INDIANA DEPARTMENT OF TRANSPORTATION

APPROVED MINUTES

May 21, 2009 Standards Committee Meeting

RE: Minutes for the May 21, 2009 Standards Committee Meeting

802-SNGP-01 SIGN PLACEMENT

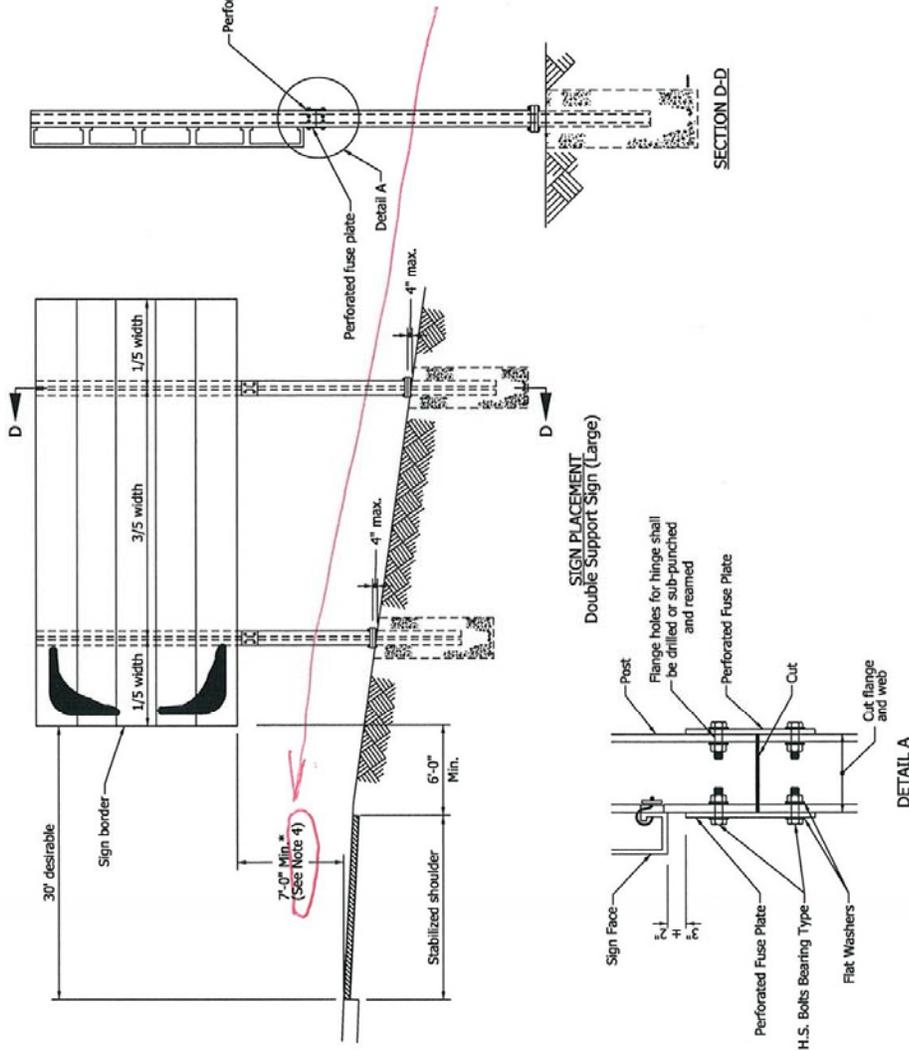
During the last meeting with District Traffic Engineers a question was raised about this Standard Drawing and it was pointed out that this present Standard Drawing 802-SNGP-01 does not give the details about the minimum height of the panel sign above the ground in case of up slope or elevated ground. This Standard Drawing gives the details about mounting height of the panel sign for down slopes only.

I am proposing a change in this Standard Drawing. The change being proposed is only an addition in the notes stating that "in case of up slope or elevated ground, the bottom of the outer edge of the panel sign shall be 7 ft. min. above ground."

1. No more than one W10 x 19 or larger post can be used in a 7'-0" path. No more than two W8 x 18 or smaller posts can be used in a 7'-0" path.
2. For 3 post installation, the edge of sign to post is 1/6 width of sign and 1/3 width of sign between posts.
3. See E 802-SNGP-04 for base plate details.
4. In case of up slope or elevated ground, the bottom of the outer edge of the panel sign shall be 7'-0" min. above ground.

STANDARD DRAWING NO. E 806-SGFB-03

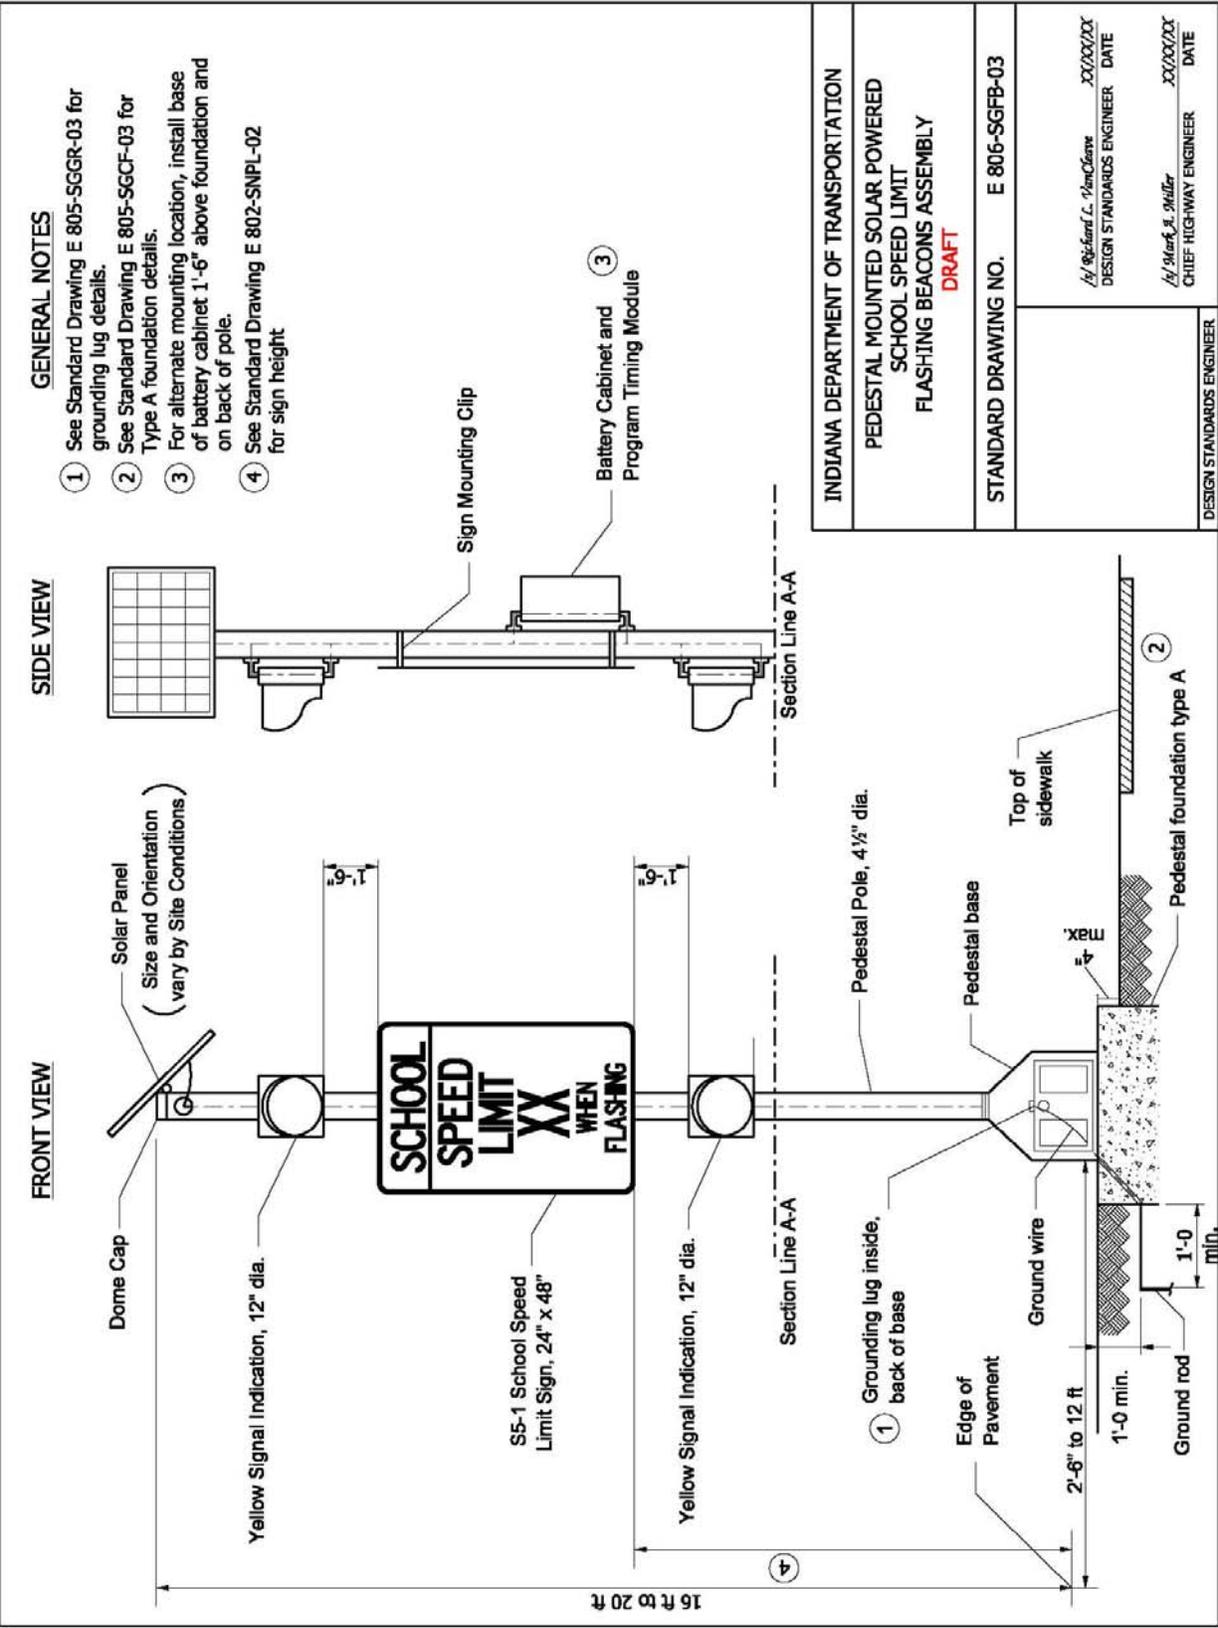
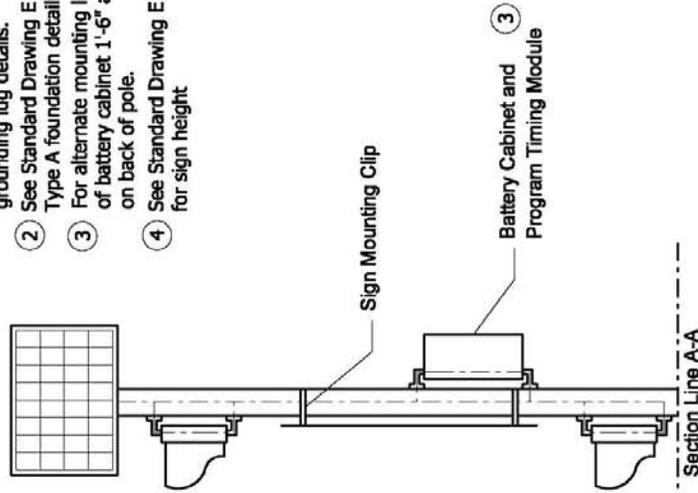
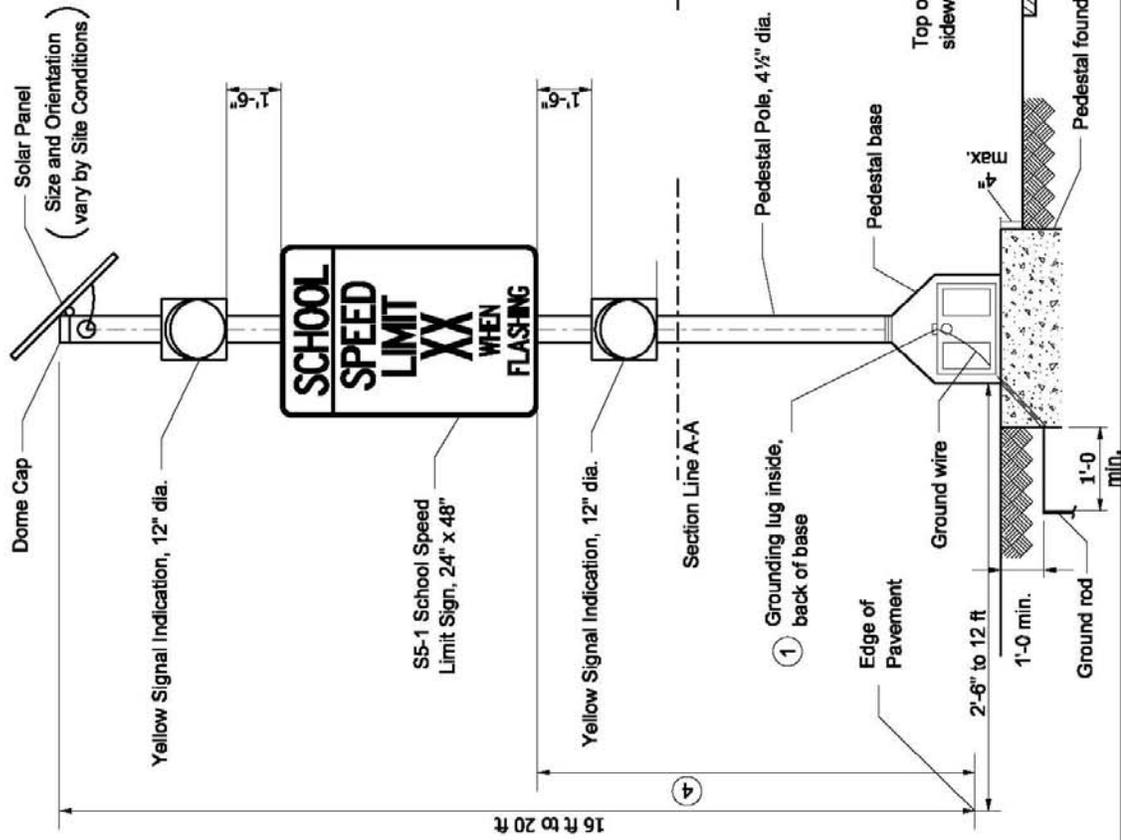
Due to the increasing use of solar-powered flashing beacons in rural areas, the district traffic engineers requested that a specification and standard drawing be developed for this type of traffic control device.

The proposed solution involves two standard drawings and four additional specifications to the 800's section of the spec book.

Figure 52-13F

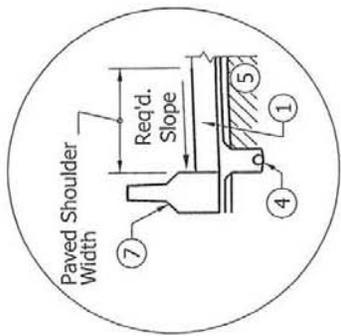
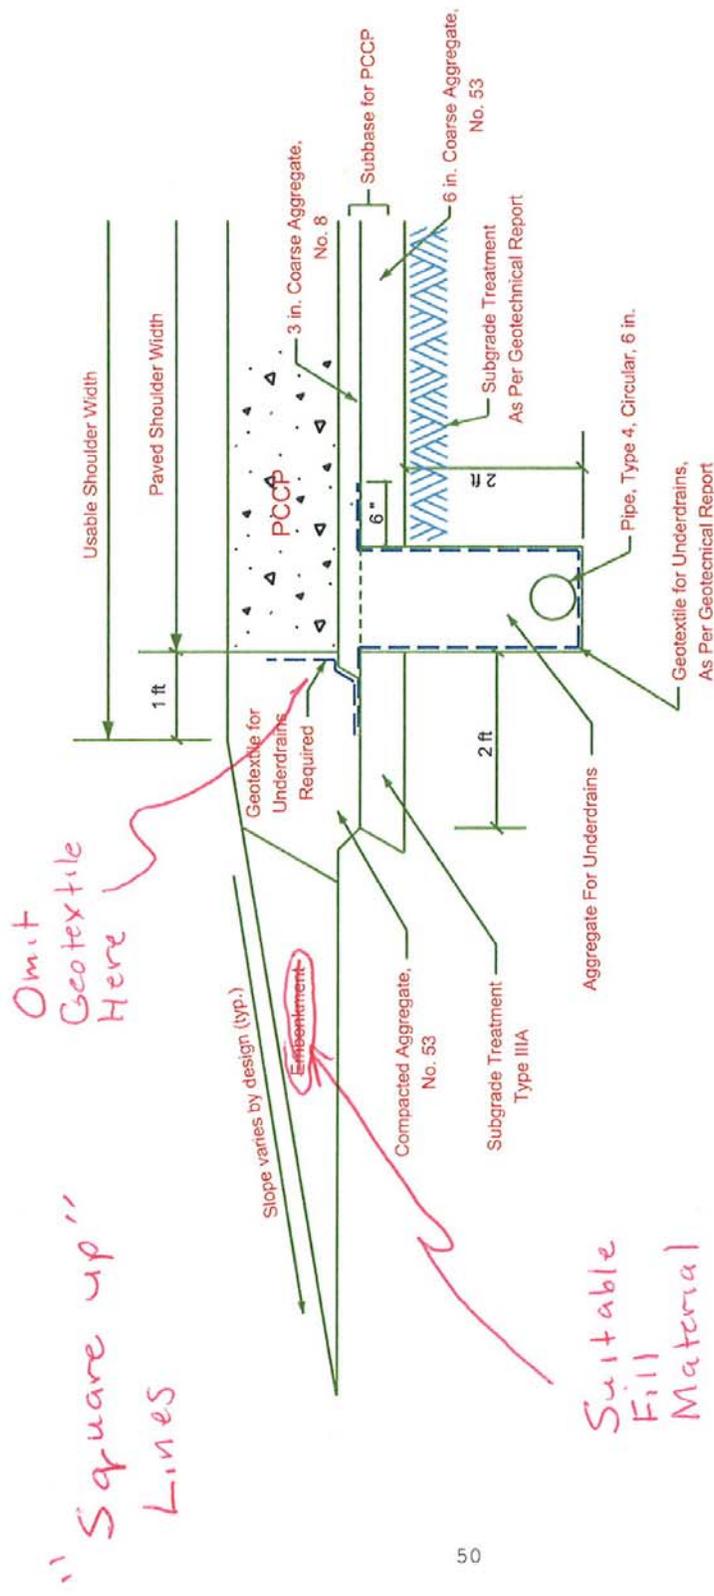
PROBLEM(S) ENCOUNTERED: Revised IDM PCCP Typical Section. Executive Office efforts to reduce Construction costs resulted in the generation of Pavement Cost Savings Proposition #08002.

PROPOSED SOLUTION: Revised Typical Section will save approximately \$64,000.00 per mile of 4 lane divided highway. Savings will be realized by minimizing aggregate wedge at edge of shoulder and by eliminating compacted aggregate placed for the sole purpose of providing a construction platform for the paver tracks and replacing it with Subgrade Treatment Type IIIA.

DISCUSSION: Mr. Byers of ACPA discussed some Industry concerns and issues pertaining to construction of the draft revised typical section.

Figure 52-13P

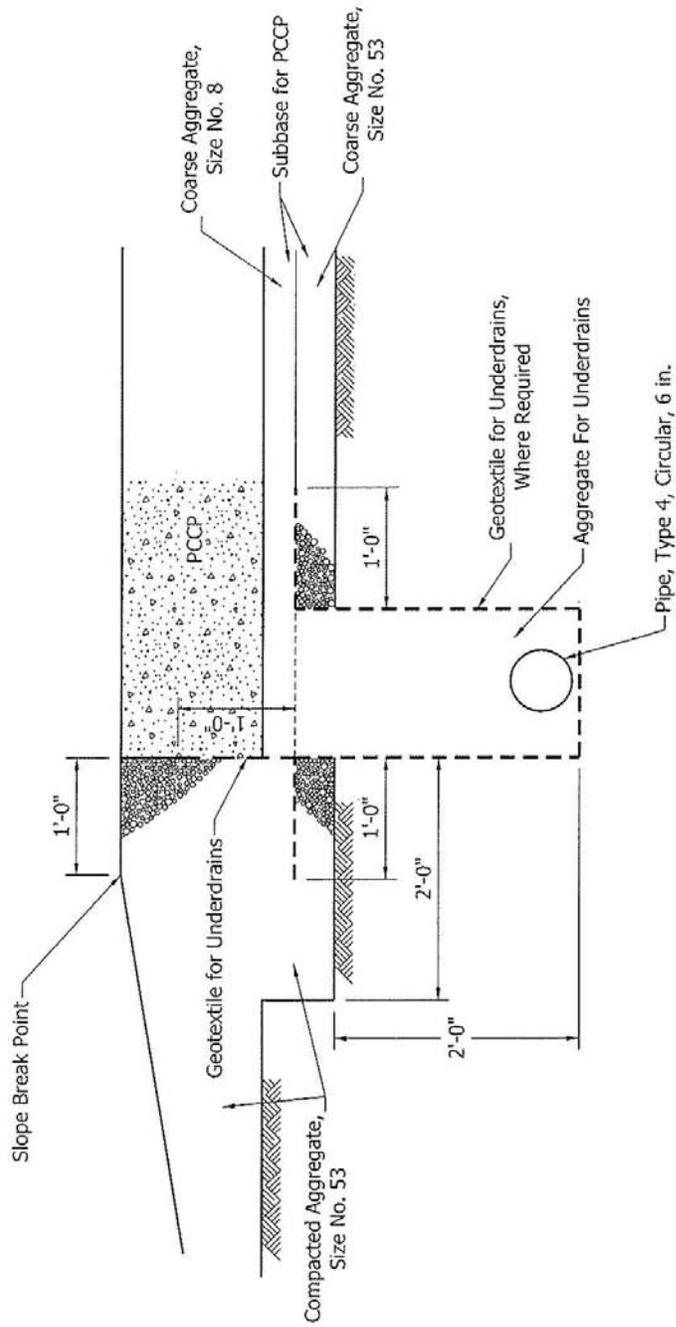
- a) Assume "Type IA" (Remove)

- b) "Type IIIA" (Replace at Subbase)

2) Subbase for PCCP (Remove)

3) Compacted Aggregate, No. 53 (Remove 3" Coarse Agg. No. 8 & replace with CA)

4) Compacted Aggregate, No. 53 (Assume 6:1 slope) Remove

5) Borrow (Remove # 53 outside shoulder break point and replace with Borrow)
